STAFF RECOMMENDATION 2509 Natchez Trace January 21, 2015

Application: New construction-infill and outbuilding
District: Hillsboro-West End Neighborhood Conservation Zoning Overlay
Council District: 18
Map and Parcel Number: 104150048800
Applicant: Randy Robinson
Project Lead: Paul Hoffman, paul.hoffman@nashville.gov

Description of Project: The applicant proposes new construction of a single-family residence and outbuilding on one of three newly subdivided lots in an area that was originally two lots. The outbuilding does not include living space.

Sheet:
S1.01

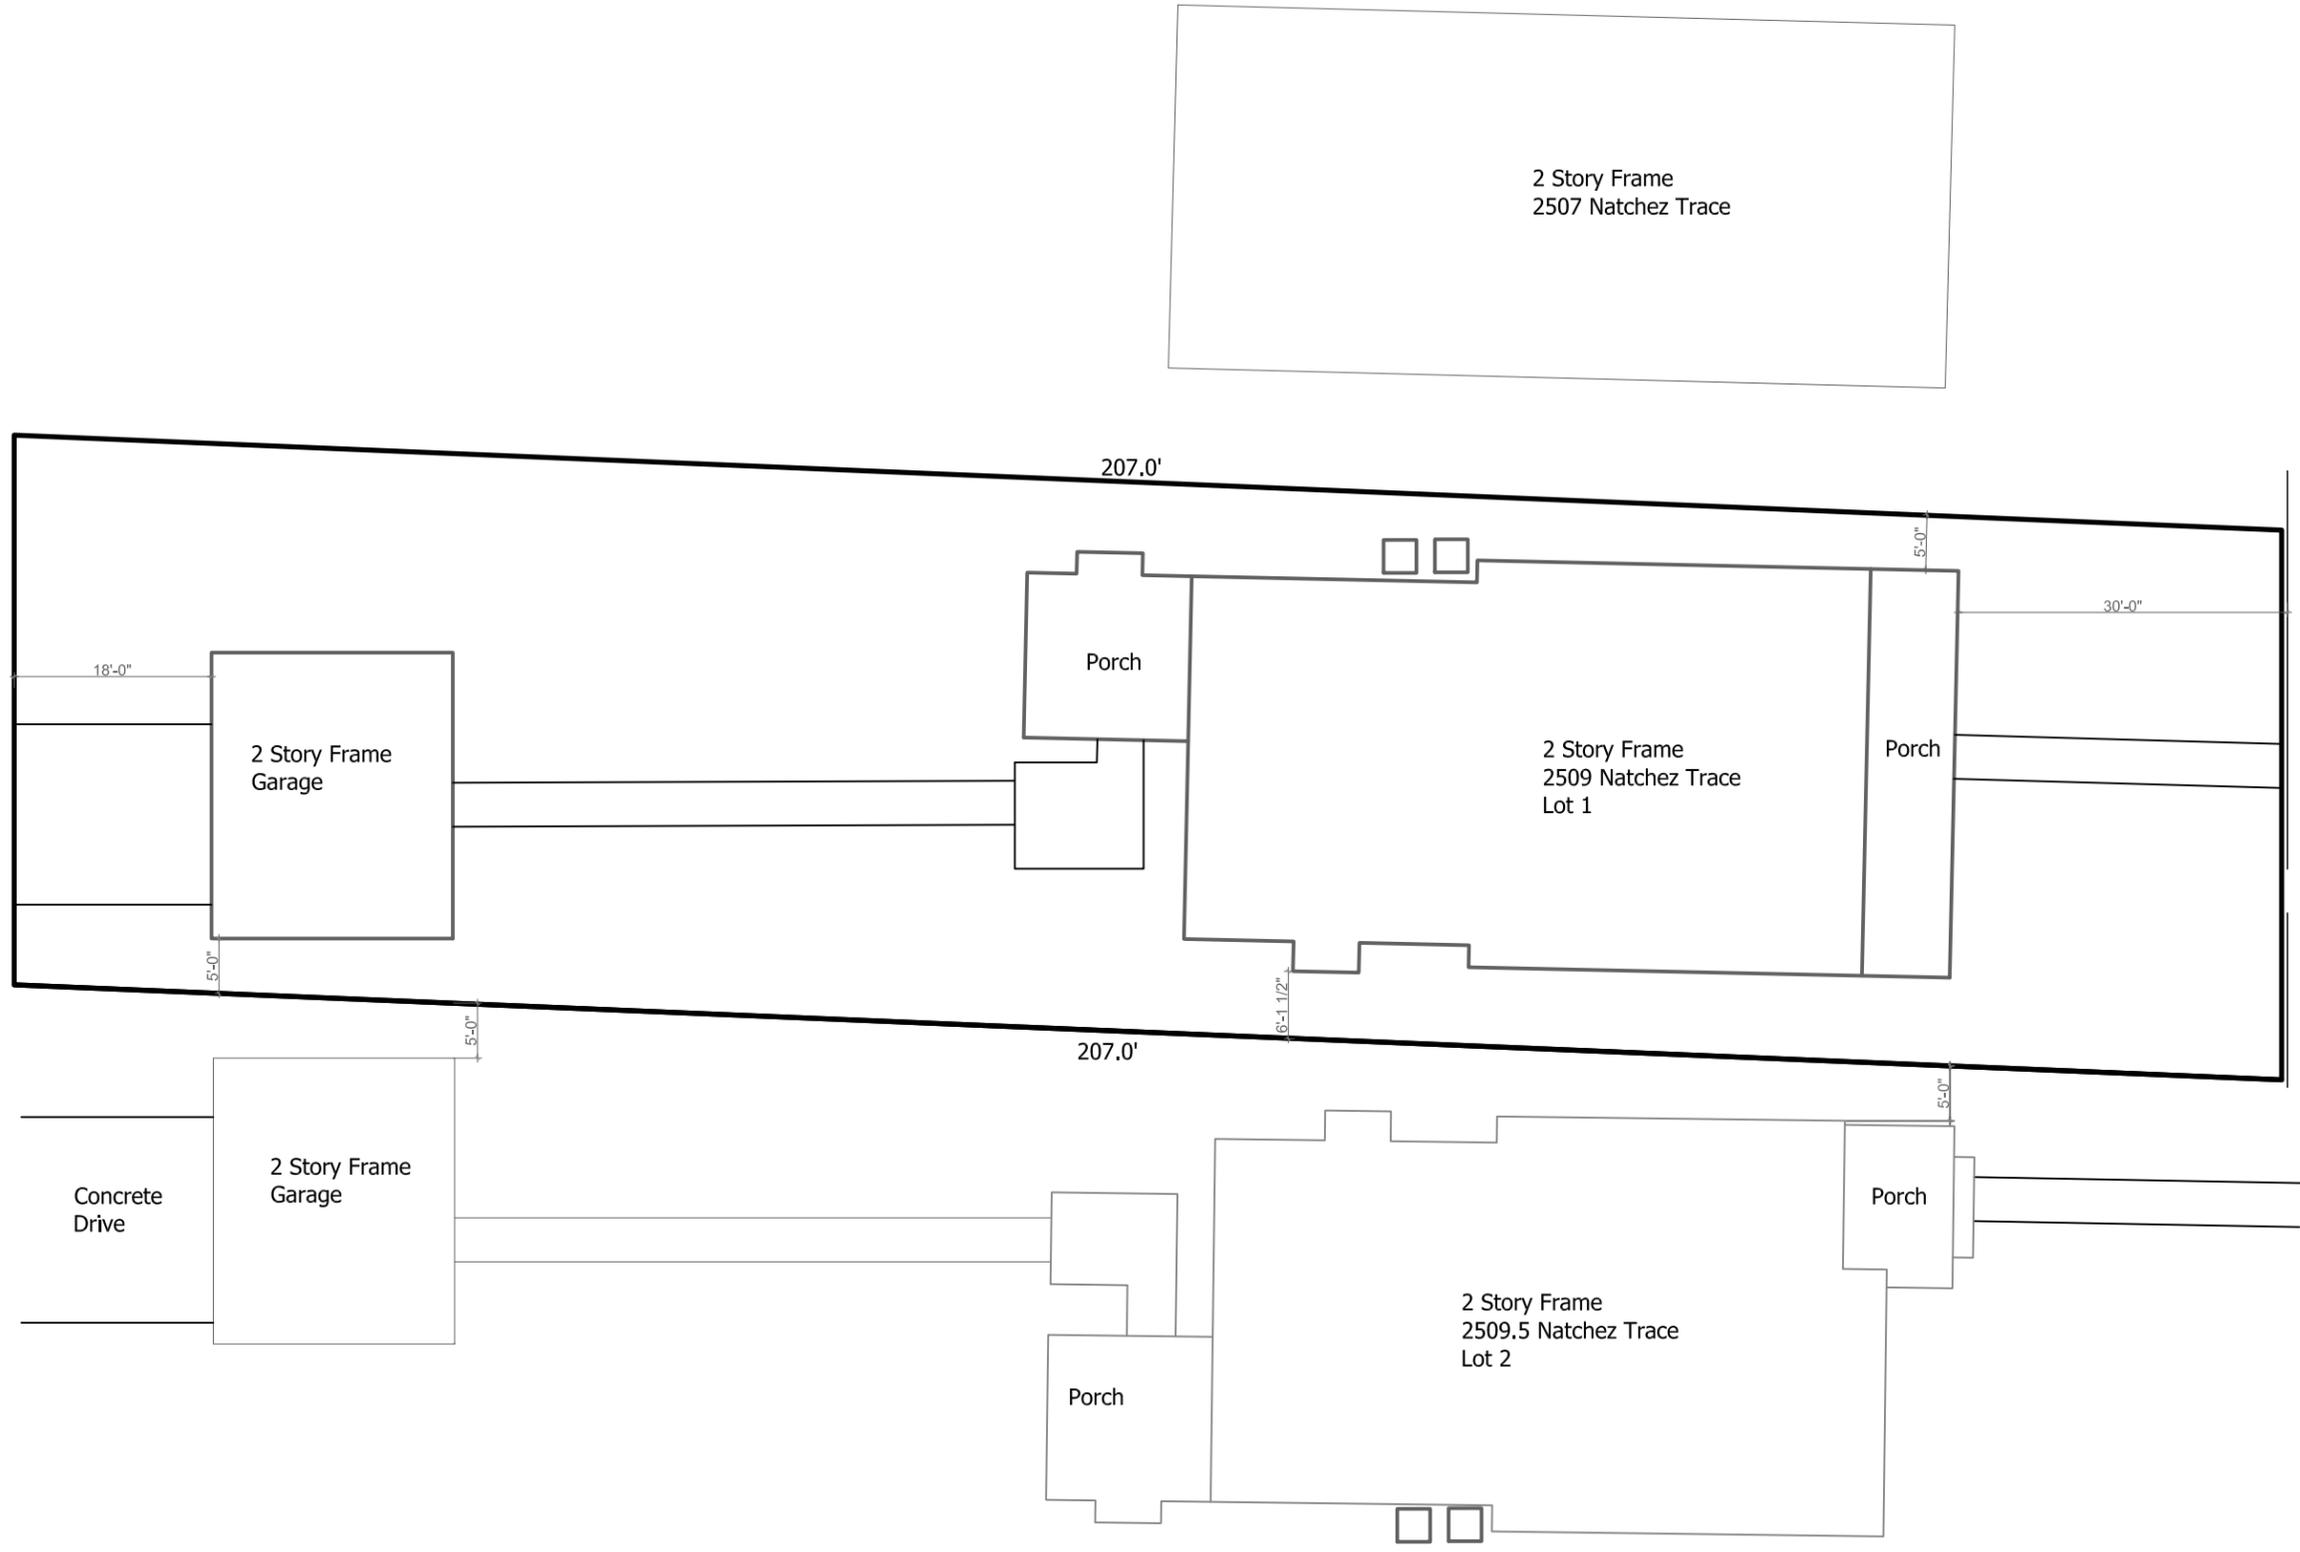
Setback & Rhythm of Spacing: The side setbacks are five feet (5') and six feet, six inches (6'6"). The rear setback will be approximately one hundred and five feet (105'). These meet base setback requirements of five feet (5') on the sides and twenty feet (20') at the rear. The site plan shows the front wall approximately one foot (1') forward of the wall of the contributing home next door, to the right. Staff recommends that the infill be situated to meet the street setback of 2507 Natchez Trace. The project meets section II.B.1.c.

1. That the street setback meet that of 2507 Natchez Trace, the contributing home next door;
2. The outbuilding's eave height be lowered to no more than ten feet (10');
3. The outbuilding's dormers be redesigned to be roof dormers, sitting back from the wall beneath by no less than two feet (2');
4. The finished floor height shall be consistent with the finished floor heights of the adjacent historic houses, to be verified by MHZC staff in the field;
5. Staff approve the final details, dimensions and materials of the siding material, windows, doors and garage doors prior to purchase and installation;
6. Lap siding have a maximum five inch (5") reveal; and,
7. Staff approve the color of roofing material for the residence and outbuilding.

Sheet:
A4.01

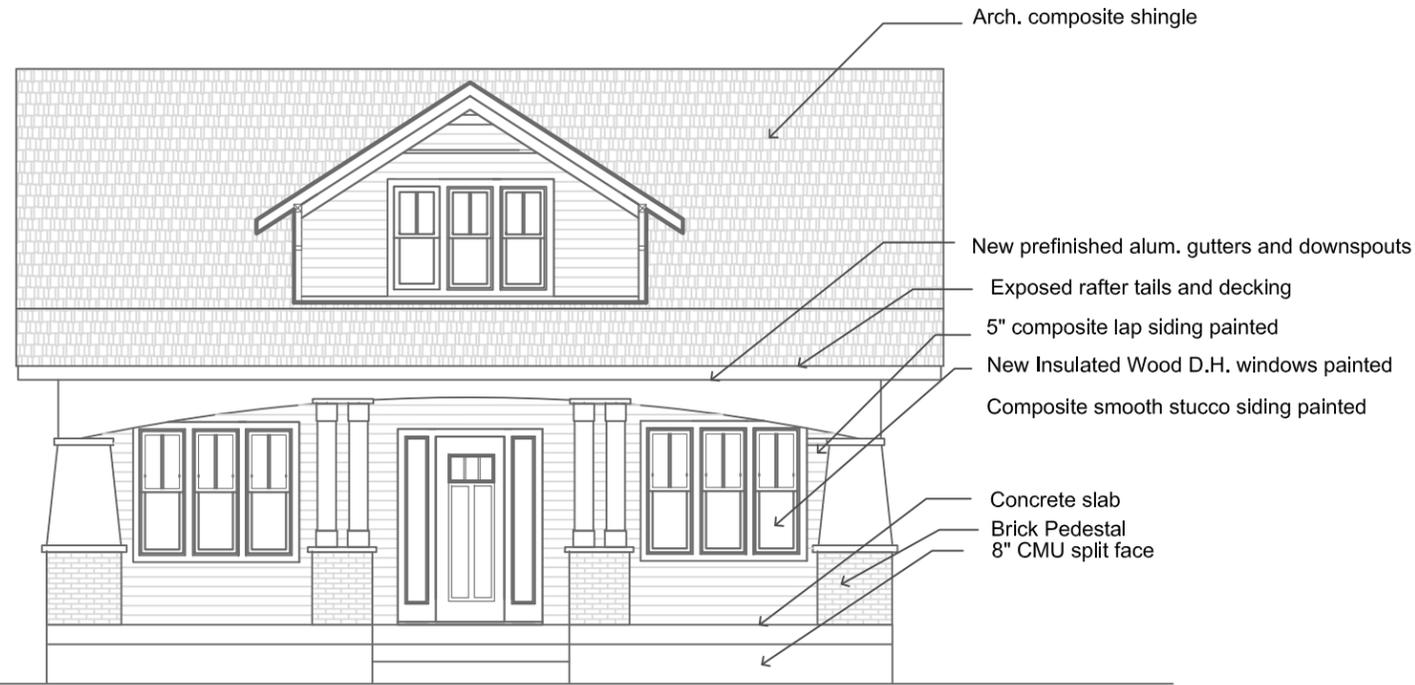
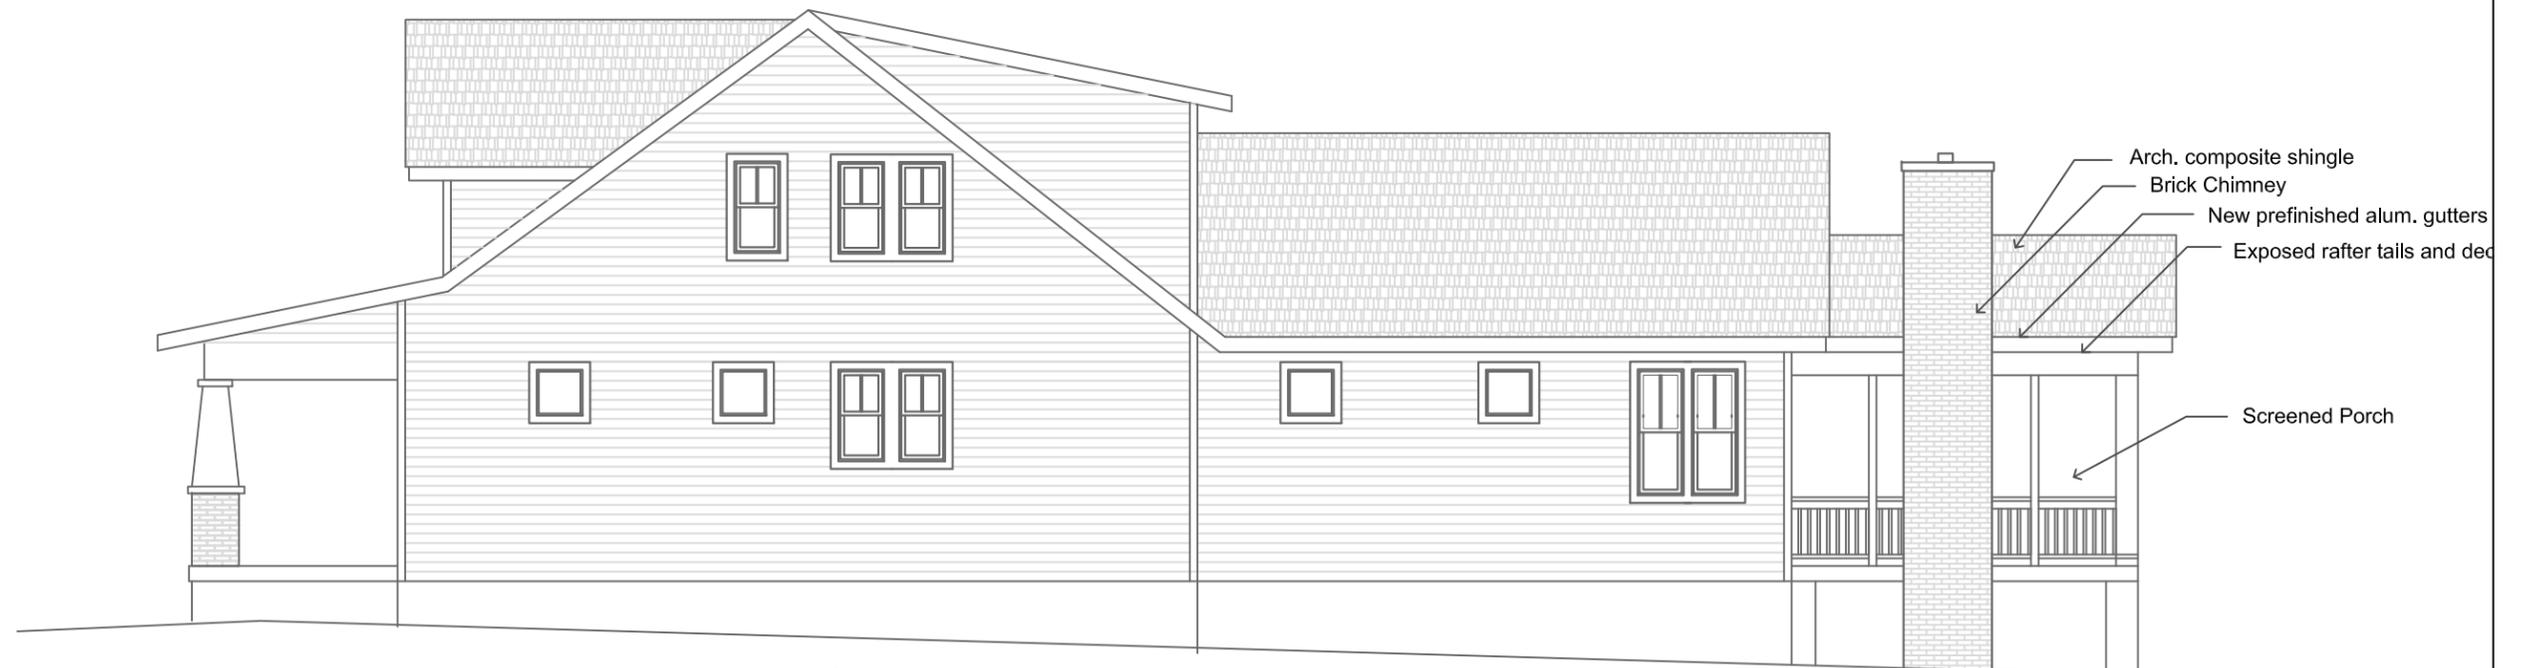
Height & Scale: The new building will be one and a half stories with a ridge height of twenty-seven feet (27') from grade. Contributing homes in Hillsboro-West End range from eighteen to twenty-nine feet (18'-29') in height. The neighboring contributing home at 2507 Natchez Trace (see Figure 1) is twenty-seven feet (27') from grade.

The proposed foundation height will be two feet (2'). The foundations of neighboring houses on Natchez Trace range from one to three feet (3'). The house is proposed to be thirty-seven feet (37') wide. The range of neighboring buildings is from thirty-three to forty feet (33'-40'). The proposed eave height is ten feet (10') from the finished floor height. The massing of the depth of the house is mitigated with a lower ridge line for the

back half and because a portion of the back half will be a one-story open porch. Staff finds the height and scale of the proposed building to be compatible with the context. The project meets section II.B.1.a and b.

Roof form: The roof form is a side gable with a gabled front dormer and a shed rear dormer. The rear wing of the house is gabled to the rear. The primary roofs have 7/12 pitch. The shed roof and porch roof are 3/12. The roof form and pitches are compatible with surrounding historic buildings. The project meets section II.B.1.e.

Sheet:
A7.01

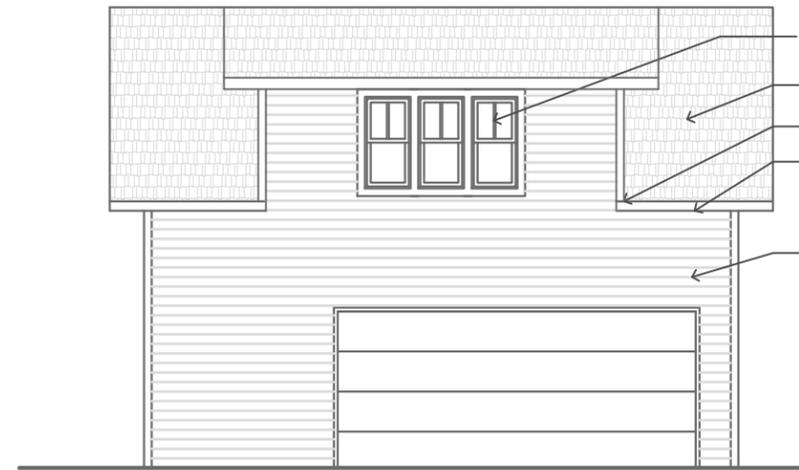
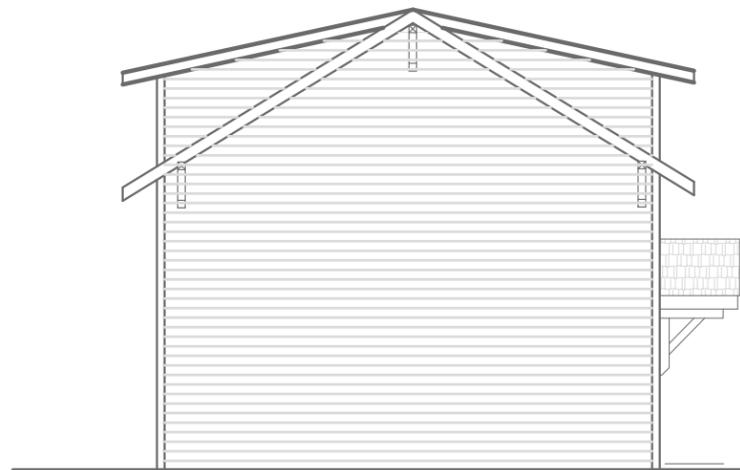
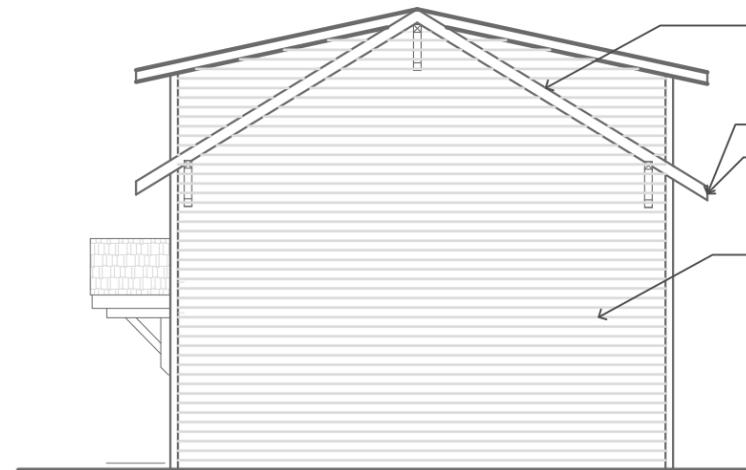
Height & Scale: The eave height of the outbuilding is eleven feet (11'). Staff requests the eave height be lowered to no more than ten feet, in accordance with section II.B.h of the design guidelines for outbuildings.

Character, Details, Roof: The proposed design of the outbuilding is compatible with the house. The roof is a side-gabled form with approximately 8/12 pitch. The dormers as drawn cover exactly 50% of the roof plane, but as they are wall dormers, they do not sit back from the wall. Staff requests the dormers sit back from the exterior wall by no less than two feet (2').

Materials, Siding & Trim: The materials will be the same as for the proposed residence. It will be built on a concrete slab. The siding material was not specified; Staff requests approval of the material. Siding reveal also was not specified, and Staff asks that the reveal be no greater than five inches (5"). Roofing will be architectural shingles in a color to be approved by Staff.
